## United States Patent and Trademark Office

APPLICATION NO.	FILING DATE	FIRST NAMED INVENTOR	ATTORNEY DOCKET NO.	CONFIRMATION NO.	
10/774,400	02/10/2004	Benjamin Arnette Lagrange	839-1383	9775	
30024 NIXON & VA	30024 7590 05/16/2007 NIXON & VANDERHYE P.C.			EXAMINER	
901 NORTH GLEBE ROAD, 11TH FLOOR			VERDIER, CHRISTOPHER M		
ARLINGTON,	VA 22203		ART UNIT	PAPER NUMBER	
			3745		
			MAIL DATE	DELIVERY MODE	
•			05/16/2007	PAPER

Art Unit: 3745

Applicant's Amendment dated February 26, 2007 has been carefully considered but is non-persuasive. At the outset, Applicants and the Attorney of Record are thanked for their wishes for a speedy recovery as well as their offer of an interview.

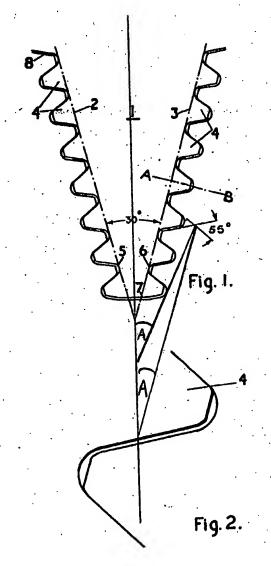
Claims 29-30, as far as they are definite and understood, are rejected under 35 U.S.C. 102(b) as being anticipated by United Kingdom Patent 677,142. Note the unnumbered buckets for insertion into unnumbered wheelposts of an unnumbered turbine rotor in a first or second stage of a turbine, the buckets being formed from interleaved unnumbered fillets and tangs 4 which complement interleaved fillets and tangs formed in the wheelposts, the interleaved system of fillets and tangs on the buckets and wheelposts acting to reduce stresses acting on the fitted buckets and wheelposts, the fillets and tangs of the interleaved system each being formed by a combination of curved and straight surfaces, with the uppermost tangs on each side of a center line bisecting each of the buckets each respectively defining a point of a respective line that forms an angle of 20.782 degrees with the center line, with each of the points being determined by intersecting tangent lines along pressure faces of the respective uppermost tangs, and a point defined by intersecting tangent lines along pressure faces of the bottommost tang does not lie on either line that forms the angle of 20.782 degrees with the center line. The bucket has three interleaved tangs and fillets. Note that these claims still do not specifically recite the particular geometry of the intersection of the angle formed by tangent lines along uppermost tangs on each side of the center line bisecting each of the buckets. That is, a line drawn from the intersection of the angle formed by tangent lines to pressure faces of the two uppermost tangs (shown in figure 1 of United Kingdom Patent 677,142 at the intersection near the marked 55 degree angle as an example) on each side of a center line bisecting each of the buckets may be selectively drawn such that it intersects the center line (at a portion of the center line remote from the blade root) and forms the aforementioned 20.782 degree angle, with the lines defined by the uppermost tangs not coinciding with a point formed by the bottommost tang, such that this angle

is the same as Applicant's angle E of 20.782 degrees in figure 10, since the location where the drawn line that forms the angle E intersects the center line is an arbitrary location. See the annotated figure below.

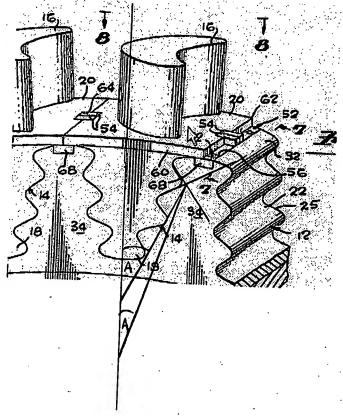
Claims 29-32 and 34-36, as far as they are definite and understood, are rejected under 35 U.S.C. 102(b) as being anticipated by Webb 3,202,398. Note the buckets 16 for insertion into wheelposts 34 of a turbine rotor 10 in a first or second stage of a turbine, the buckets being formed from interleaved unnumbered fillets and tangs which complement interleaved fillets and

tangs (near 22) formed in the wheelposts, the interleaved system of fillets and tangs on the buckets and wheelposts acting to reduce stresses acting on the fitted buckets and wheelposts, the fillets and tangs of the interleaved system each being formed by a combination of curved and straight surfaces, with the uppermost tangs on each side of a center line bisecting each of the buckets each respectively defining a point of a respective line that forms an angle of 20,782 degrees with the center line, with each of the points being determined by intersecting tangent lines along pressure faces of the respective uppermost tangs, and a point defined by intersecting tangent lines along pressure faces of the bottommost tang does not lie on either line that forms the angle of 20.782 degrees with the center line. The bucket has three interleaved tangs and fillets. The bucket has a bottom tang 18 formed from curved surfaces having more than one radius of curvature. The bucket further includes at least one straight surface (the leading and trailing edges). The bucket has an upper tang formed from curved surfaces having more than one radius of curvature. Note that these claims still do not specifically recite the particular geometry of the intersection of the angle formed by tangent lines along uppermost tangs on each side of the center line bisecting each of the buckets. That is, a line drawn from the intersection of the angle formed by tangent lines to pressure faces of the two uppermost tangs on each side of a center line bisecting each of the buckets may be selectively drawn such that it intersects the center line and forms the aforementioned 20.782 degree angle, with the lines defined by the uppermost tangs not coinciding with a point formed by the bottommost tang, such that this angle is the same as Applicant's angle E of 20.782 degrees in figure 10, since the location where the drawn line that forms the angle E intersects the center line is an arbitrary location. See the annotated figure below.
